Company	Trenz Electronic GmbH
PCN Number	PCN-20250215
Title	TE0723-03 to TE0723-04 Hardware Revision Change
Subject	Hardware Revision Change
Issue Date	2025-06-18

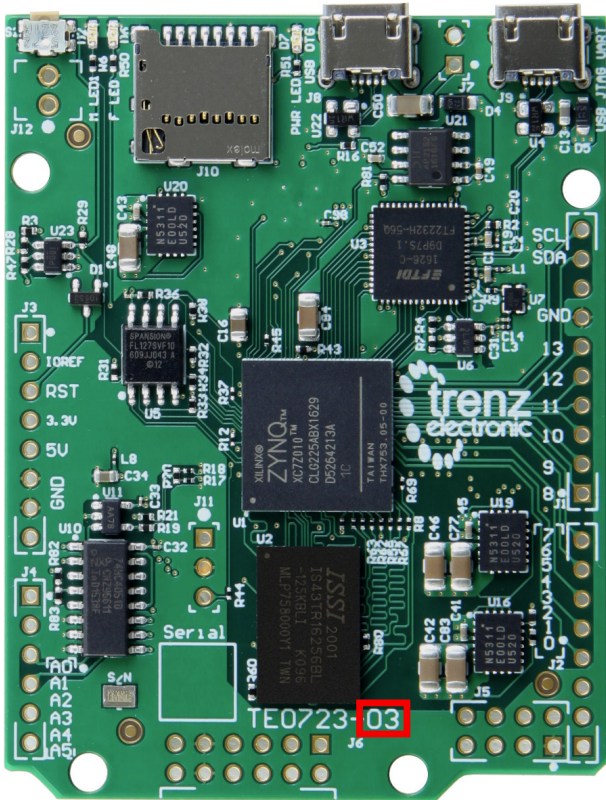
#15 Added UKCA- and RoHS-logo.

Type: PCB Change

Reason: Improve product classification.
